ADDENDUM - 01

PARTIAL HVAC RENOVATION-MARY
SHOEMAKER SCHOOL

RYEB Project #5652Aa

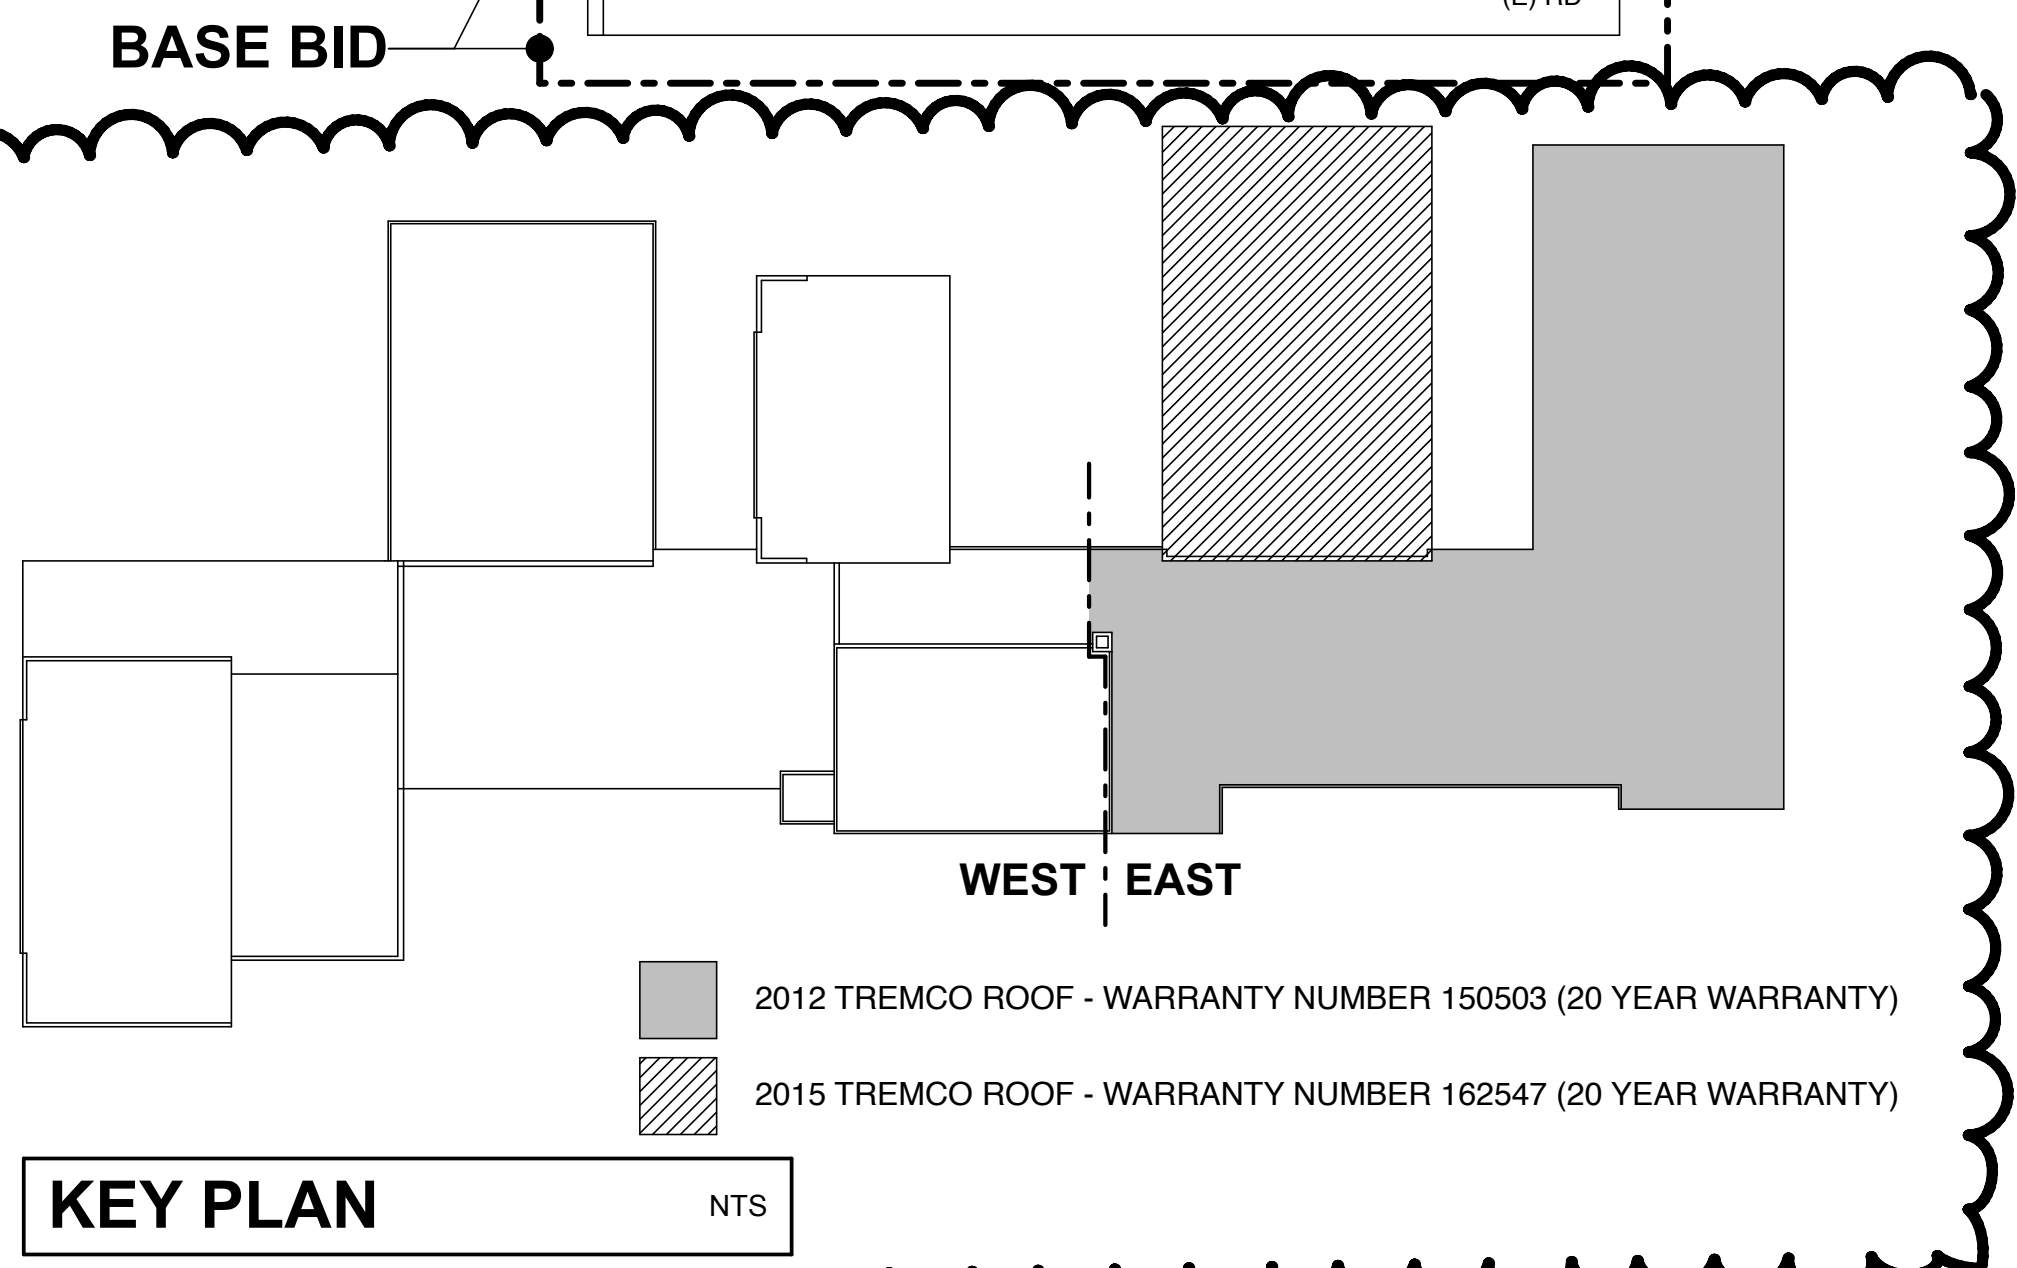
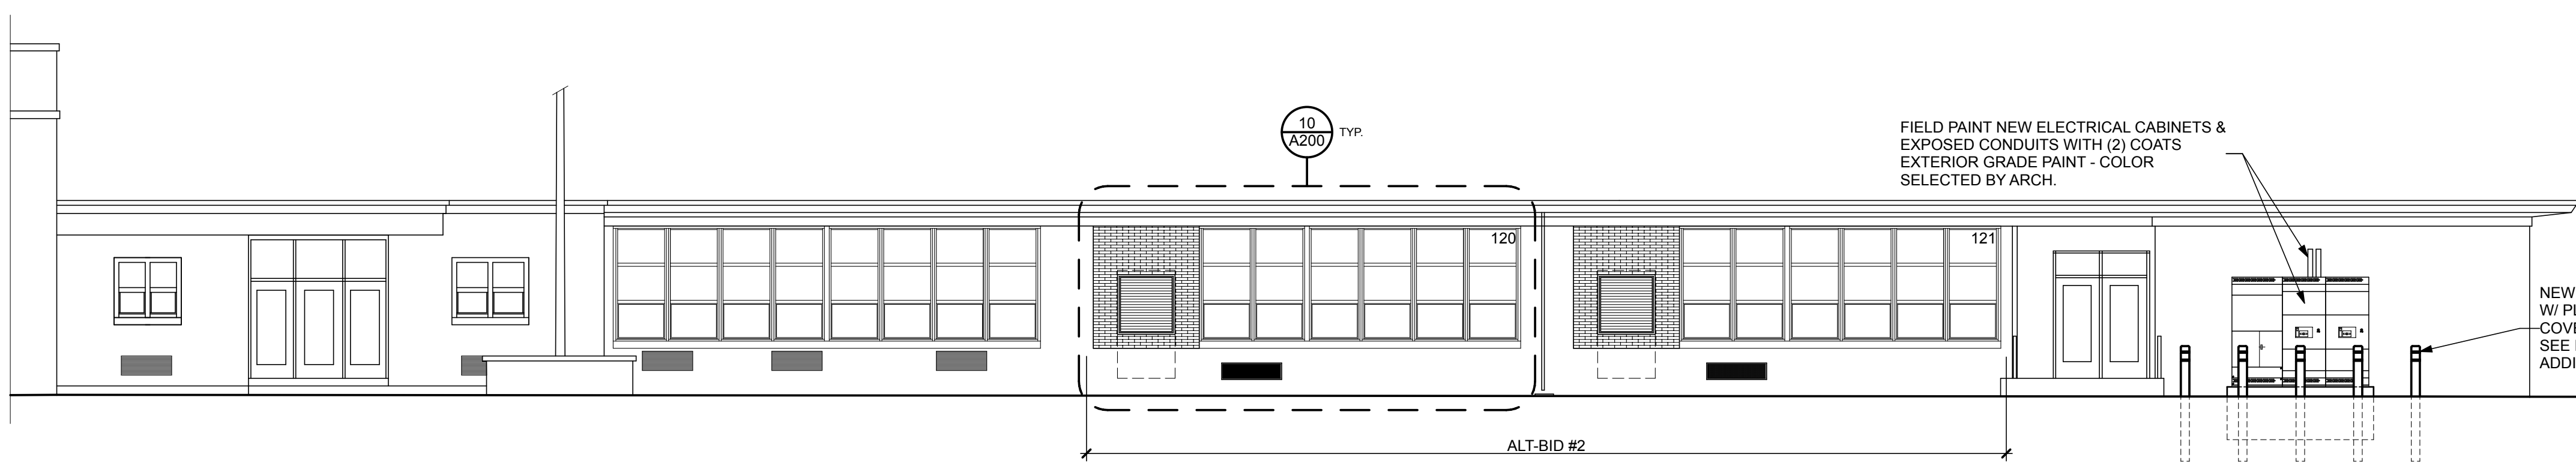
- 1.04 **Bidder Comment:** The Equipment key on A102 has text over the key. **Response:** Drawing sheet A102 has been replaced and is included as part of this Addendum.

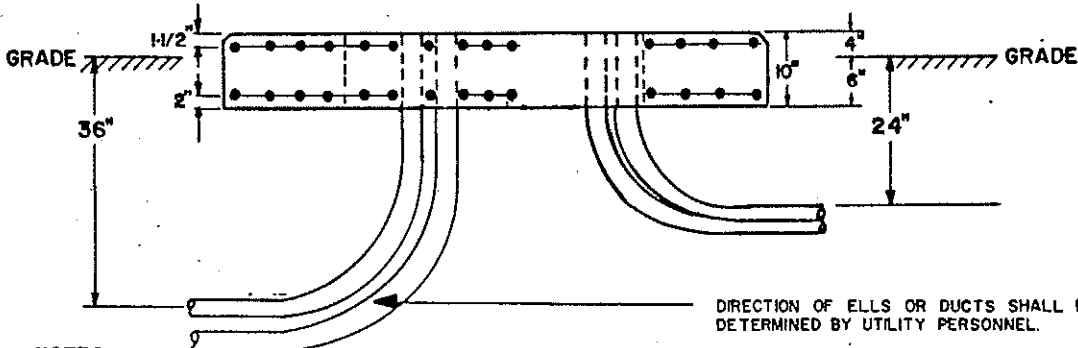
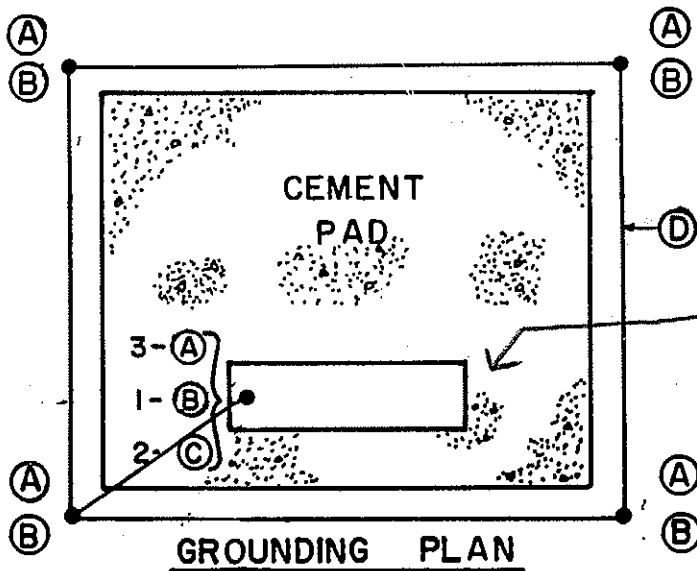
- 1.08 **Clarification:** Atlantic City Electric (ACE) has provided additional details and requirements for the concrete slab for the new transformer pad. The concrete pad, and all ACE requirements shall be constructed by the Contractor and in full accordance with ACE's requirements. Refer to attached sketch entitled, "Customer's Transformer Pad for 3-Phase Pad Mount", consisting of three pages total.

Doors of Xfmr. are on the same side as the duct window. Window needs to face away from the bldg.

SKE-2020-11-30-1

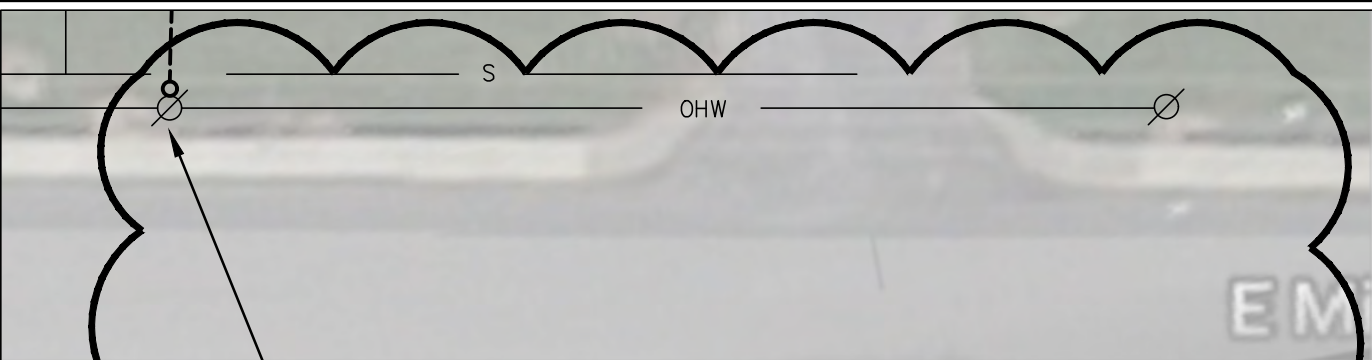
- 1.09 **Clarification:** Reference is made to Detail B/E.01, entitled "Ductbank Detail" on drawing E.01.
- Contractors shall be aware that a drainage swale exists between the electrical pole on East Millbrooke and the new transformer location. All conduits and duct bank shall be installed in a manner to maintain the proper minimum clearances as shown on the documents in accordance with the requirements of Atlantic City Electric.

- Refer to attached sketch Swale Image Detail, SKE-2020-11-30-1, prepared by Kelter & Gilligo.
- 1.10 **Bidder Question:** Question: Drawing S2 and S3 do not show Alternates. Is everything shown on these drawings also part of the Base-Bid? **Response:** The structural work required on drawings S2 and S3, are designed to support the new mechanical units and equipment.

1. PROVISIONS MUST BE MADE FOR THE INCOMING PRIMARY CONDUITS OFF THE UTILITY POLE TO SWEEP BELOW THE SWALE.
